GJS Plot F, Manchester

Non-material Amendment | 23.08.2024

Z1-SHP-A180-RP-XX-NMA02 | P02

Updated Proposal - F1-SHP-G200-EL-XX-B5D801 - P02

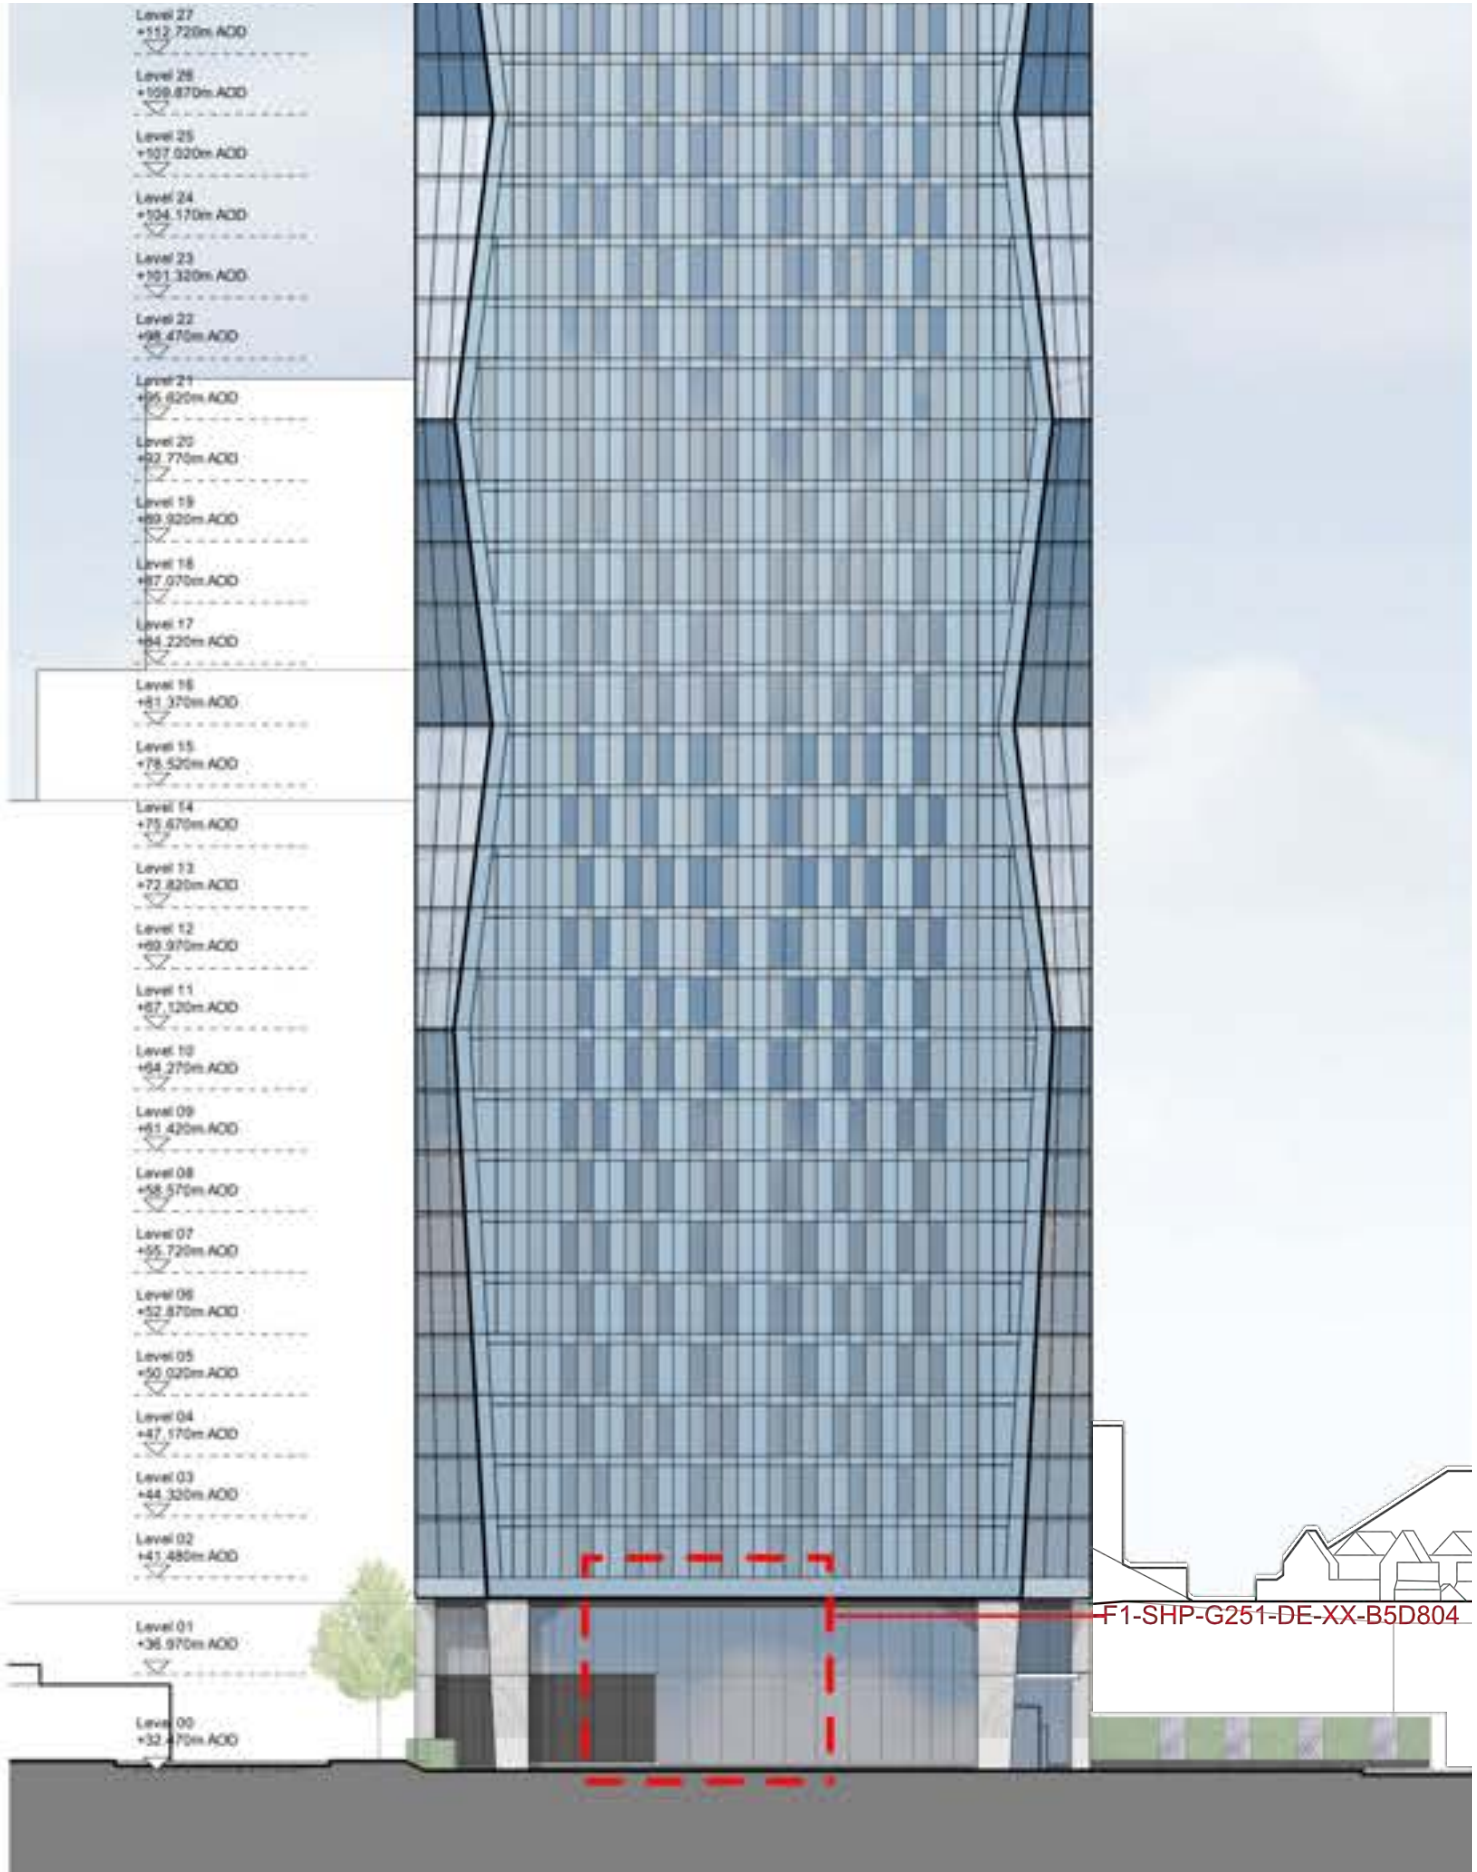
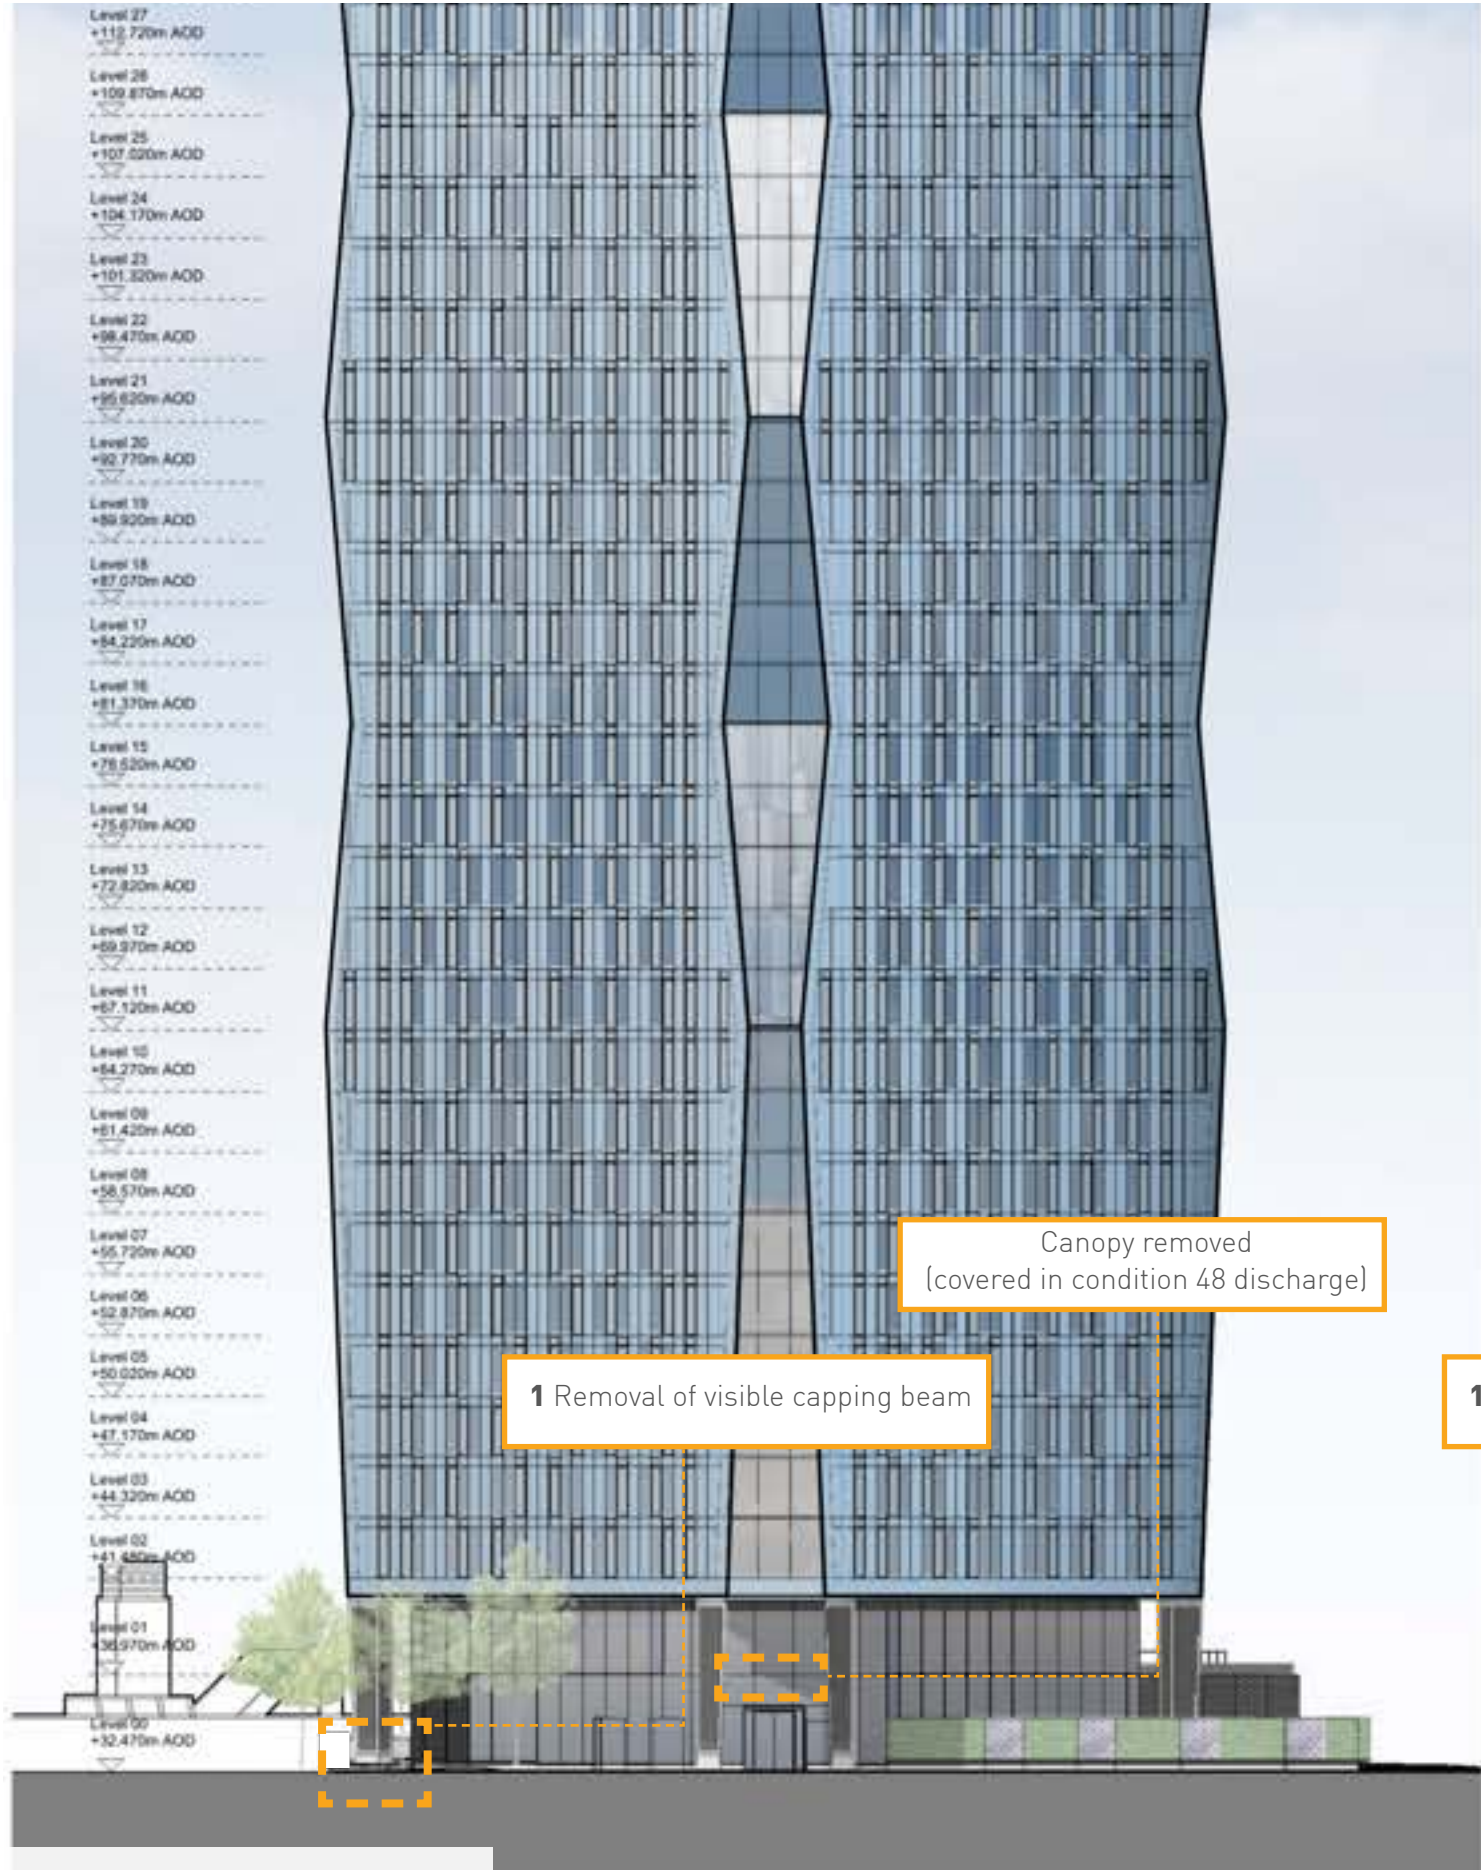
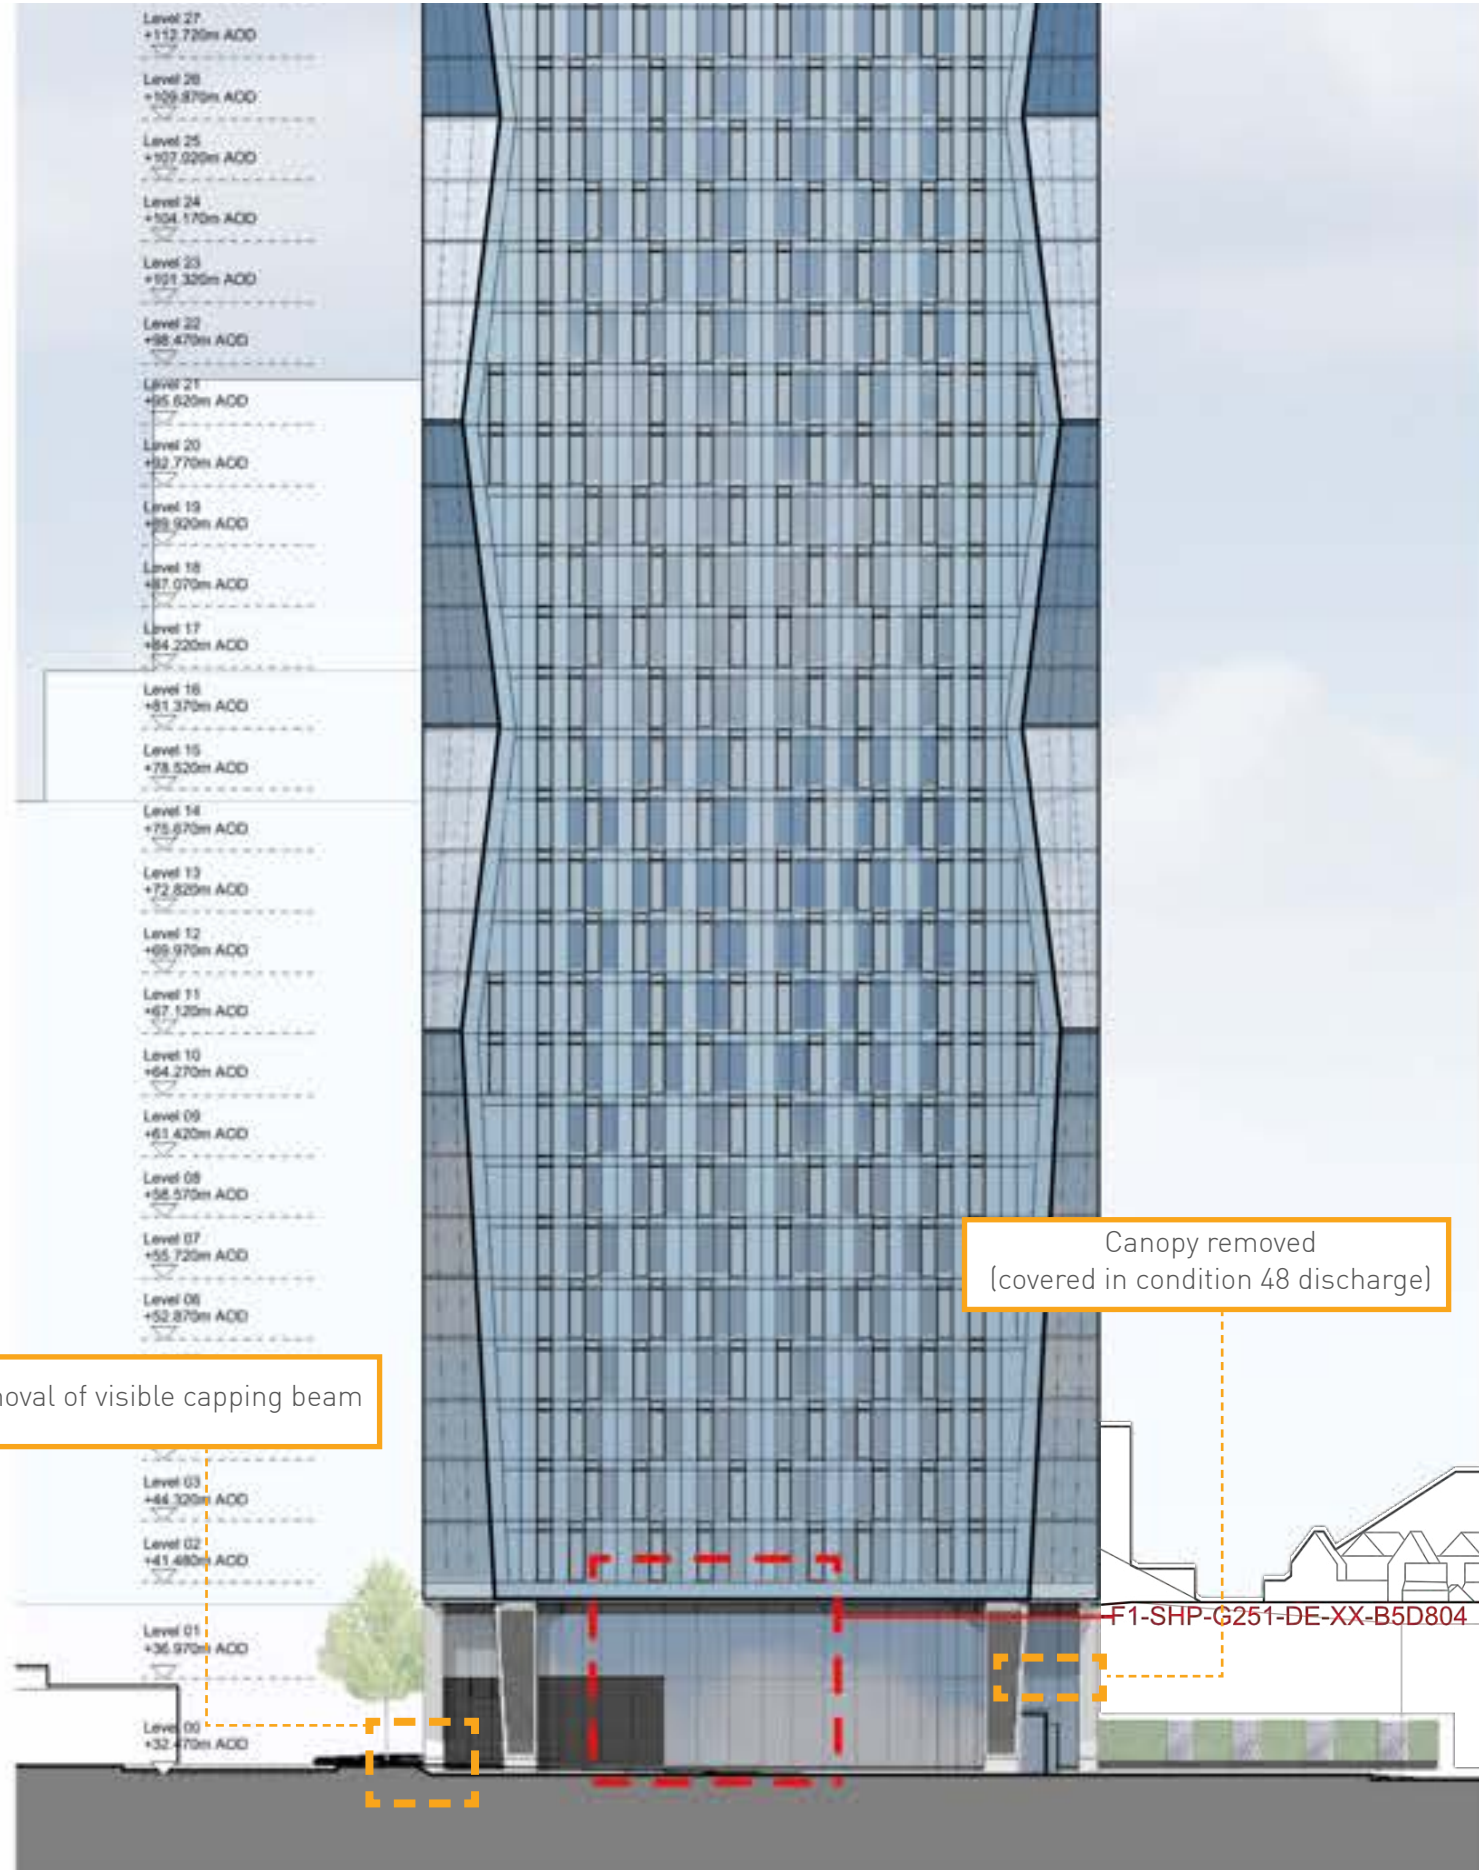
Tower F1 - Removal of visible capping beam along Great Jackson Street

At planning stage it was deemed necessary to keep the capping beam (top of the basement piled wall) above ground level, due to the proximity of the F1 capping beam to the pavement.

Through further structural design and refinement of temporary works, the design team have been able to lower the entirety of this structure so that it is not visible from street level, with the following benefits:

1 Removal of visible capping beam
